AGENDA

**Historic Preservation Board
Staff Report**

Subject: 1063 Norfolk Avenue
Author: Christy Alexander, Planner
Date: September 18, 2013
Type of Item: Historic District Grant
Project Number: PL-13-02051

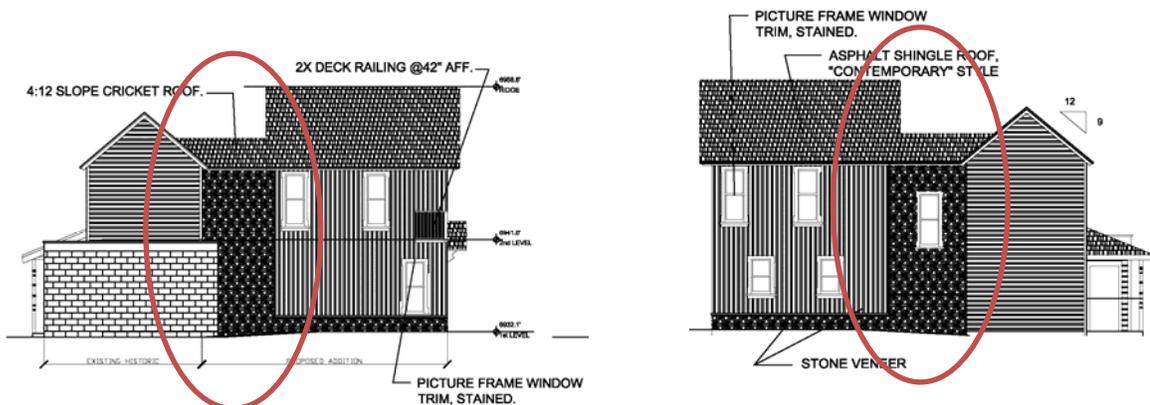
Staff finds there are discrepancies in the height of the roof. The applicant's elevation drawings show that the historic structure is 24'6" tall; however, the site plan shows the height of the roof ridge to be 21'6". The Physical Conditions Report by Preservation Solutions shows the height of the historic structure to be 24' tall. Staff recommends that if the Historic Preservation Board (HPB) denies the appeal that a licensed surveyor completes a roof plan for submittal. Therefore, it is likely that an addition measuring 26'7 1/4" will be visible from the Park Avenue elevation.
